SUNDRY NOTICES AND REPORTS ON WELLS
Do not use this form for proposals to drill or to re-enter an abandoned well. Use Form 3160-3 (APD) for such proposals.

Audacious 19 Fed Com 222H

Revised Permit Information 11/08/2023:

Operator: EOG RESOURCES INC 5509 Champions Drive Midland, TX 79706	OGRID: 7377
	Action Number: 307347
	Action Type: [C-103] NOI Change of Plans (C-103A)

WELL LOCATION AND ACREAGE DEDICATION PLAT

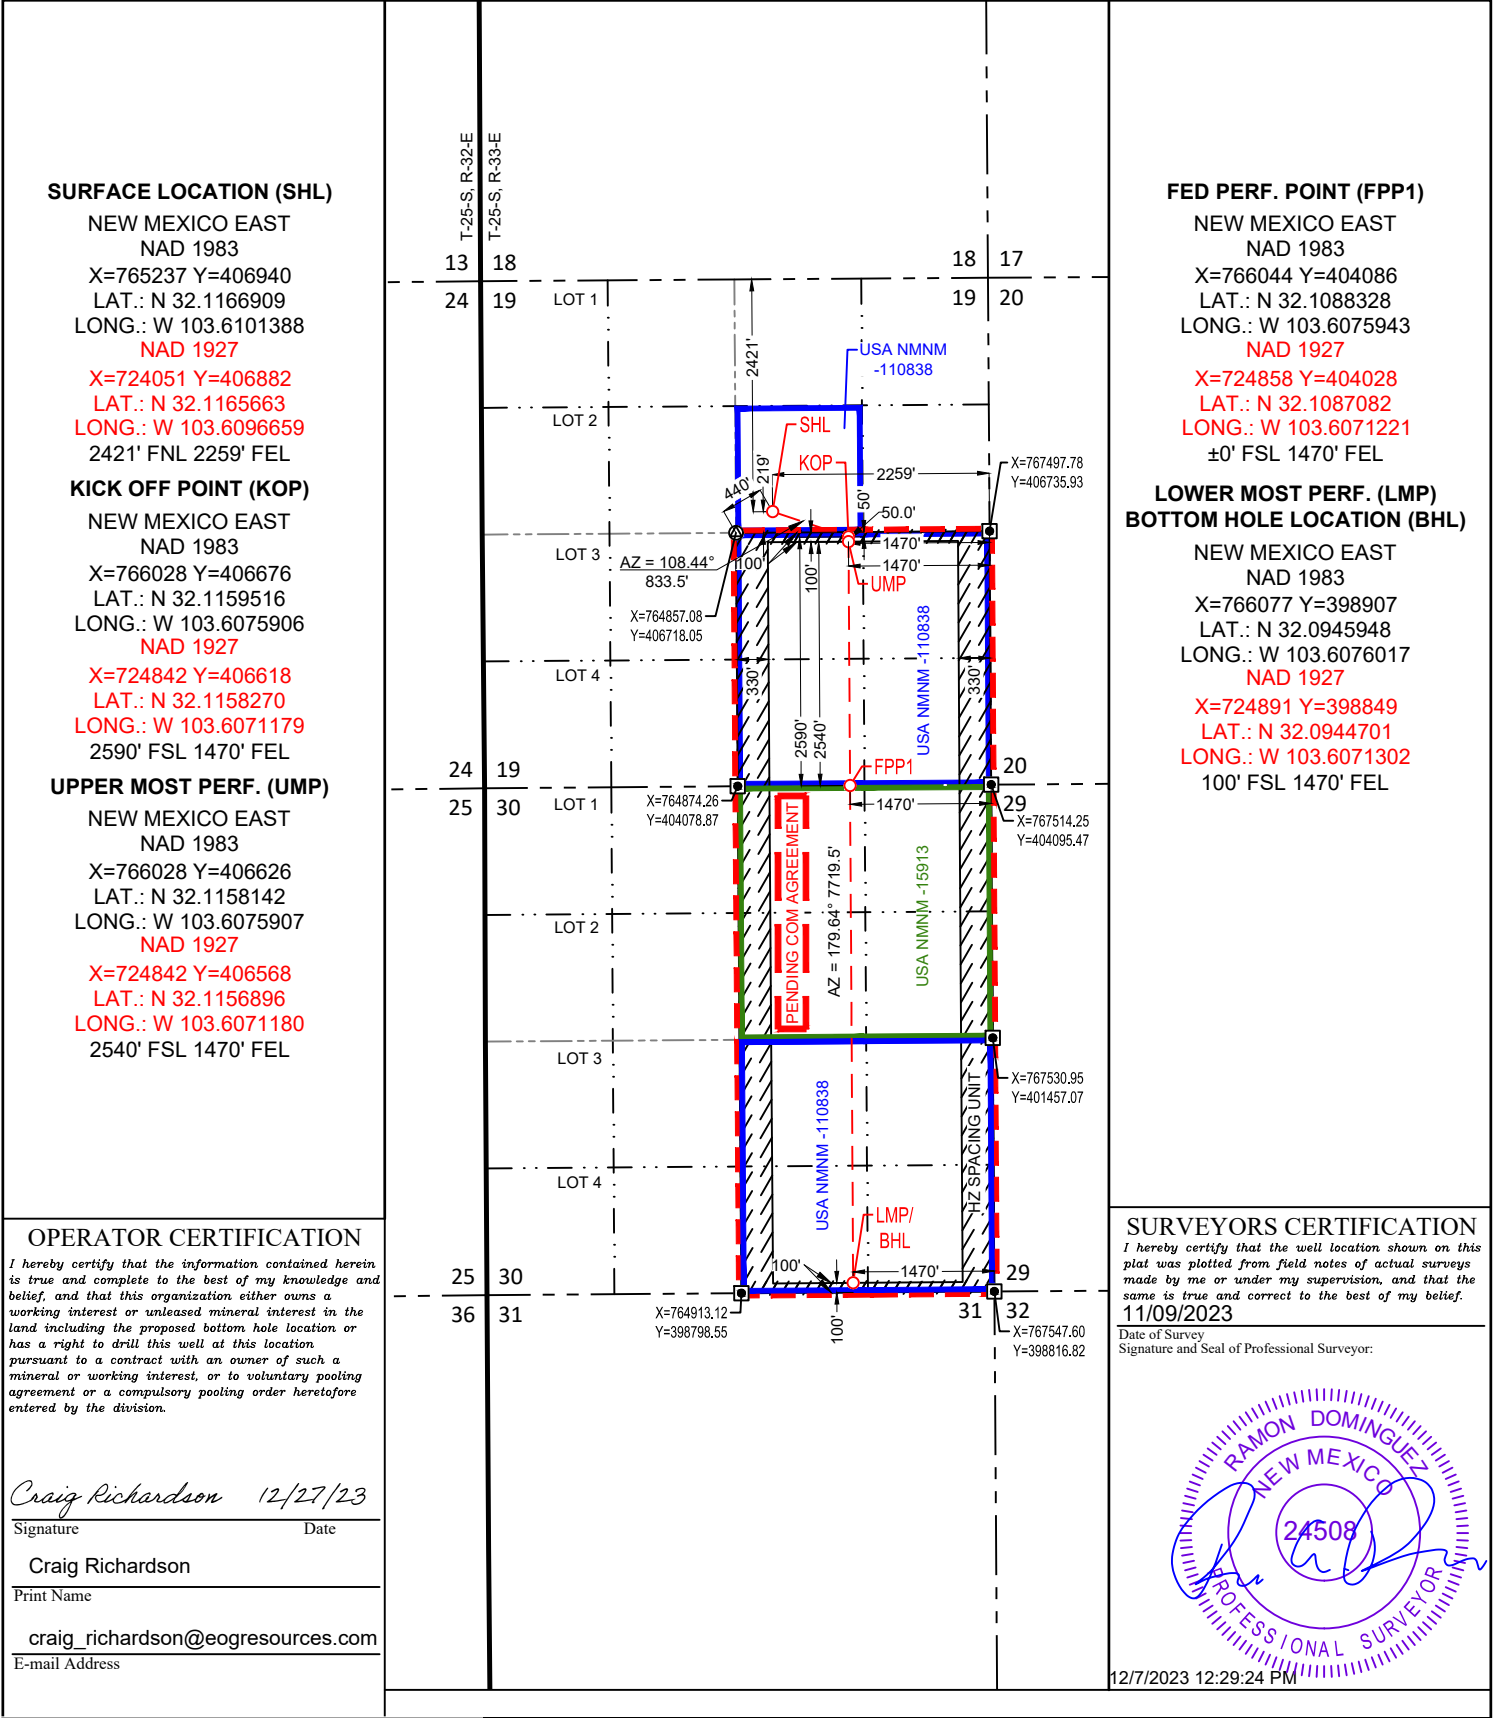
Change name from Audacious 30 Fed Com 105H to Audacious 19 Fed Com 222H.

Change SHL from T-25-S, R-33-E, Sec 30, 584' FSL, 2419' FEL, Lea Co., NM,
to T-25-S, R-33-E, Sec 19, 2421' FNL, 2259' FEL, Lea Co., N.M.

Change BHL from T-25-S, R-33-E, Sec 19, 2539' FSL, 2390' FEL, Lea Co., NM,
to T-25-S, R-33-E, Sec 30, 100' FSL, 1470' FEL, Lea Co., N.M.

UL or lot no.	Section	Township	Range	Lot Idn	Feet from the	North/South line	Feet from the	East/West line	County
G	19	25-S	33-E	-	2421'	NORTH	2259'	EAST	LEA

UL or lot no.	Section	Township	Range	Lot Idn	Feet from the	North/South line	Feet from the	East/West line	County
P	30	25-S	33-E	-	100'	SOUTH	1470'	EAST	LEA

Revised Wellbore A:

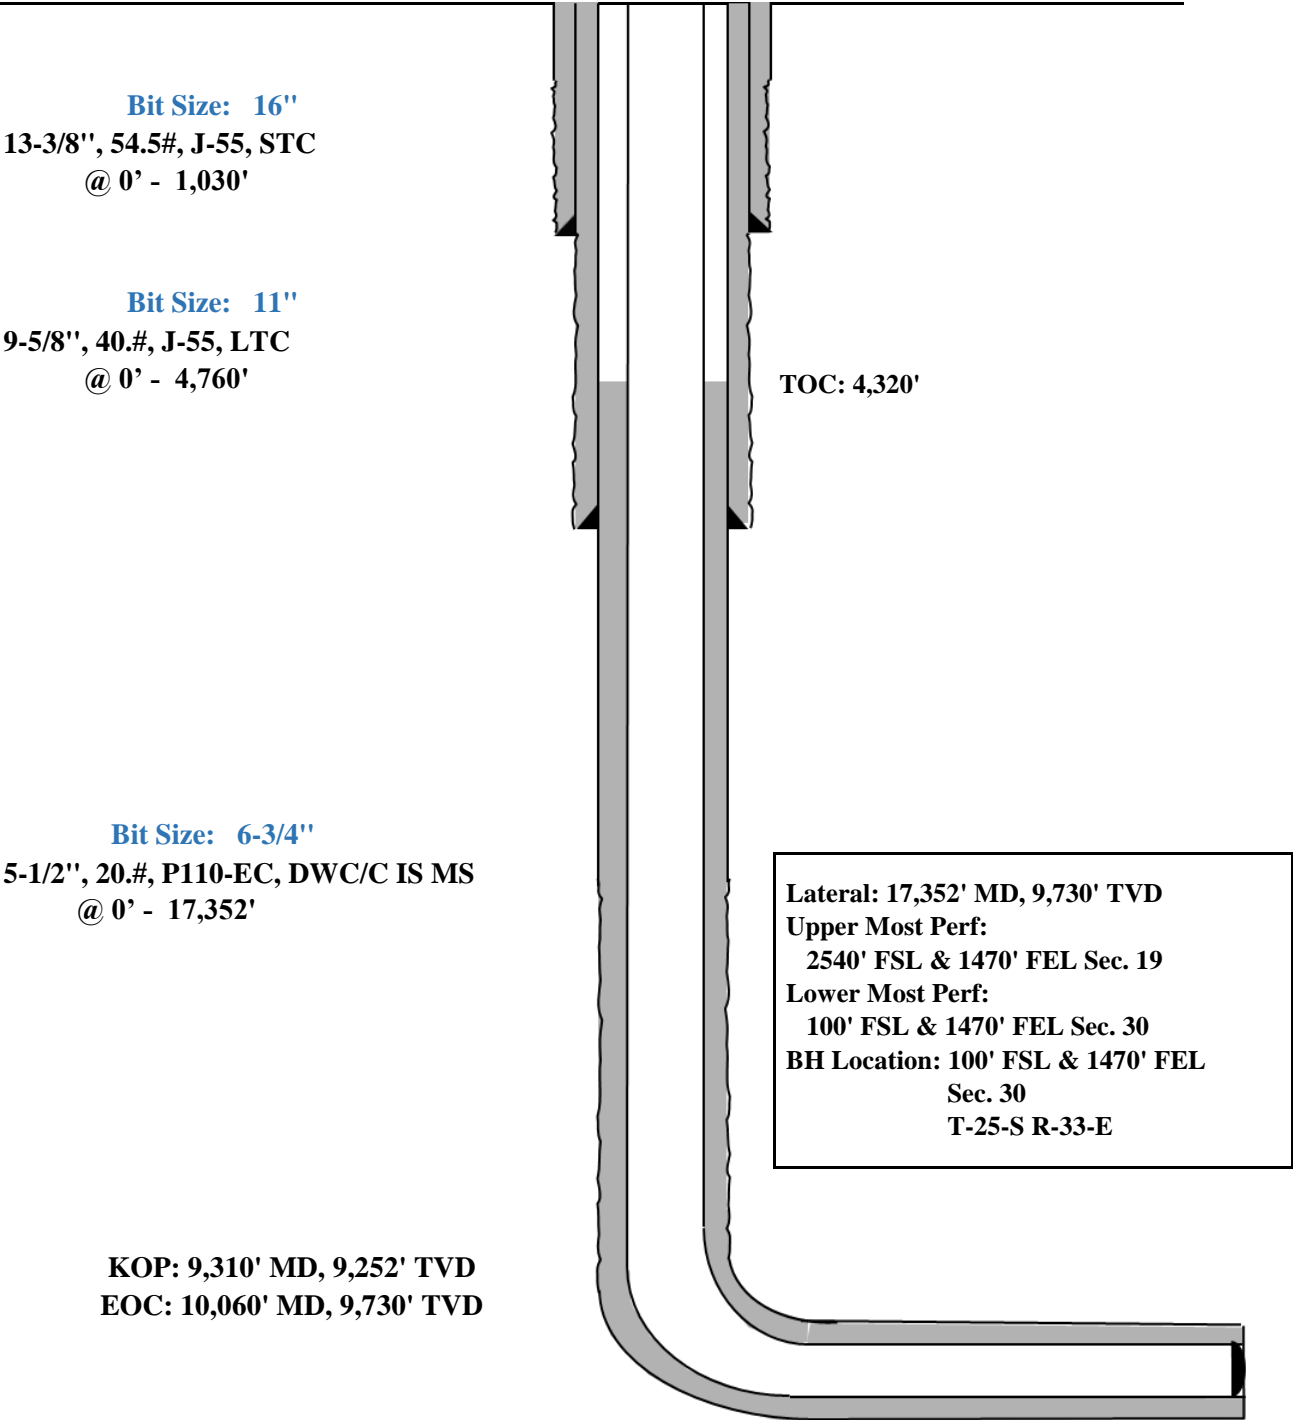
Change target formation to Leonard B.

Update casing and cement program to current design.

Hole Size	Interval MD		Interval TVD		Csg OD	Weight	Grade	Conn
	From (ft)	To (ft)	From (ft)	To (ft)				
16"	0	1,030	0	1,030	13-3/8"	54.5#	J-55	STC
11"	0	4,815	0	4,760	9-5/8"	40#	J-55	LTC
6-3/4"	0	17,352	0	9,730	5-1/2"	20#	P110-EC	DWC/C IS MS
